SUBJECT: Forwards summary on HPI sys analyses associated w/question 4
in NRC 970505 staff request for addl info.

Subject: Oconee Nuclear Station
 Docket Nos. 50-269, -270, -287
 Response to Request for Additional Information
 on the High Pressure Injection (HPI) System
 NRC TAC No. M98454

Attachment 1
Supplemental Information Regarding Question 4
in May 5, 1997 NRC Request for Additional Information

FIGURE 4.1 - CRITICAL FLAW SIZE DISTRIBUTION FOR HPI/MU NOZZLES

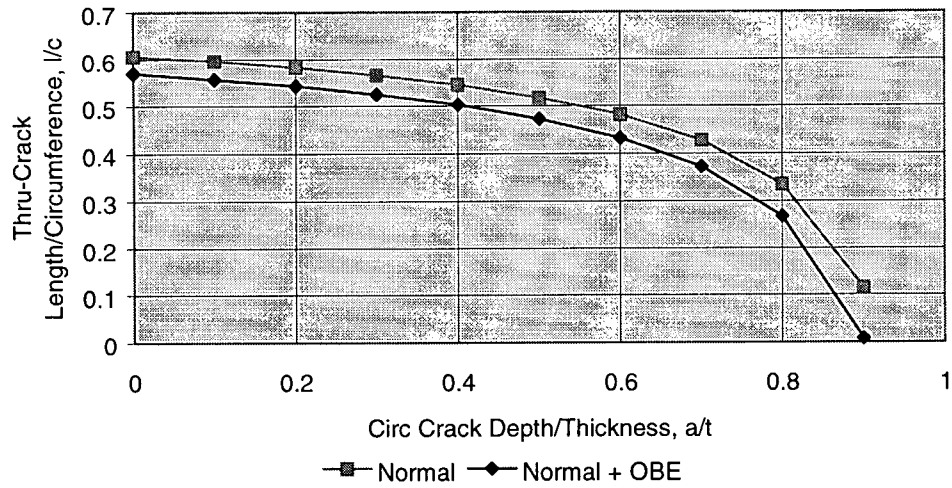
Provide a fracture analysis to determine the critical flaw size required to fracture the piping under normal loads during HPI injection or makeup conditions.

Based on the bounding stresses at the safe-end to piping welds for the 1A1 and 1A2 nozzles during normal operation, which include those which occur during HPI and makeup injection, the resulting size of critical flaws is shown in Figure 4-1. This figure shows the combination of through wall partial circumference flaws combined with a 100 percent circumferential flaw that would reach the limit load as defined in Section XI, Appendix C during normal operation with a safety factor of 1.0.

FIGURE 4.2 - ALLOWABLE FLAW SIZE DISTRIBUTION FOR HPI/MU NOZZLES

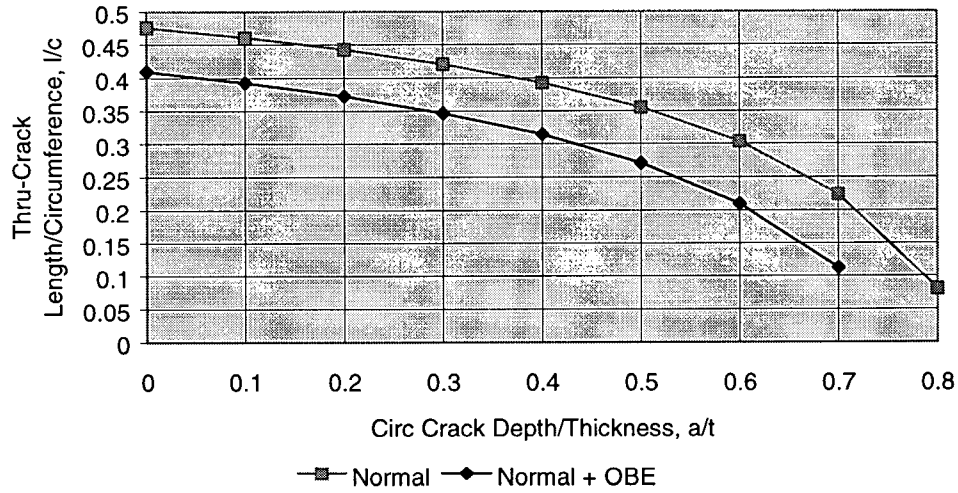
In determining the margins-to-failure, identify all assumptions and inputs into the analysis, including stresses and material characteristics.

Figure 4-2 shows the allowable flaw size that meets the stress criteria of ASME Section XI, Appendix C, including the factor of safety of 2.77. This figure shows that for a 30 percent part-wall circumferential through-wall crack, combined with a 42 percent of circumference through wall crack would meet Code stress criteria (without the OBE). With the OBE, the allowable through wall crack could be 35 percent of the circumference. The observed cracking in Unit 2 can be approximated as a 33 percent of circumference through-wall crack with a circumferential crack in the remainder of the pipe that is less than 30 percent of thickness. Thus, Section XI stress criteria is satisfied.
